OFFICE OF NEW REACTORS

**ASSESSMENT OF WHITE PAPER SUBMITTALS ON
DEFENSE-IN-DEPTH; LICENSING-BASIS EVENT SELECTION, AND SAFETY
CLASSIFICATION OF STRUCTURES, SYSTEMS, AND COMPONENTS
(REVISION 1)**

**NEXT GENERATION NUCLEAR PLANT
PROJECT 0748**

**Figure 1. Proposed dose acceptance limits for the NGNP safety analyses
(Source: Figure 3 in the NGNP LBE white paper)**

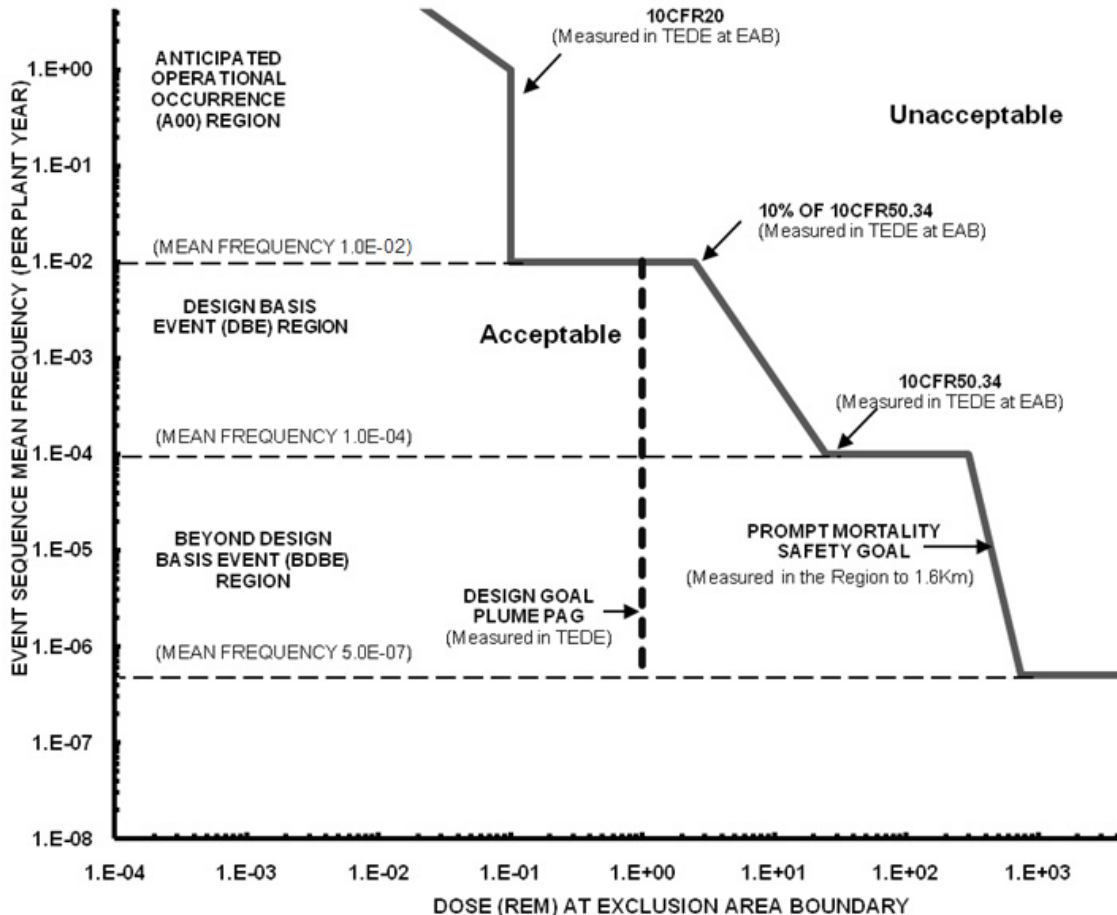
DOE/INL proposes dose acceptance limits on the LBE consequences and the analysis basis for the LBE categories, which are generally consistent with the NGNP Licensing Strategy with several significant exceptions. Figure 1, a reproduction of Figure 3 from the NGNP LBE white paper, depicts the proposed dose acceptance limits for the NGNP safety analyses.

The event frequency versus dose consequence acceptance line shown in Figure 1 is generally referred to as an "F-C curve." For events in the AE frequency region, construction of the proposed F-C curve is based on the dose limits in 10 CFR Part 20. For events in the DBE frequency region, construction of the proposed F-C curve is based on the dose limits in

10 CFR 50.34.⁷ For events in the DBE region, the proposed F-C curve has been constructed in such a manner that would reduce the dose limit as DBE frequency increases. For the DBAs (which are selected and derived from the DBEs), DOE/INL proposes that dose criteria in 10 CFR 50.34 apply (i.e., without reduction). For events in the BDBE frequency region, construction of the proposed F-C curve is based on the prompt mortality safety goal. DOE/INL proposed that the dose limits be associated with, and apply at, the NGNP EAB.

The overall construction of the proposed F-C curve generally follows an iso-risk curve to allow low doses for relatively frequent events and higher dose limits for rare events. The intent of the construction of the F-C curve is to ensure that the overall NGNP risk for all LBEs combined will meet the NRC's safety goals.

The staff recognizes that there are a large number of ways to construct an F-C curve that use the dose acceptance criteria of existing NRC regulations and applies them to inferred frequency ranges for the event categories to meet the above stated objectives. For example, the proposed frequency consequence curve shown in Figure 3-3 in NUREG-1860 was developed in connection with the NRC staff's feasibility study for a risk-informed and performance-based regulatory structure for future plant licensing. The development of the F-C curve shown in Figure 3-3 of NUREG-1860 was done using the same LWR regulations that DOE/INL used to develop its proposed F-C curve. The development of the F-C curve in NUREG-1860 also includes consideration of additional dose acceptance criteria associated with national and international radiological health standards.
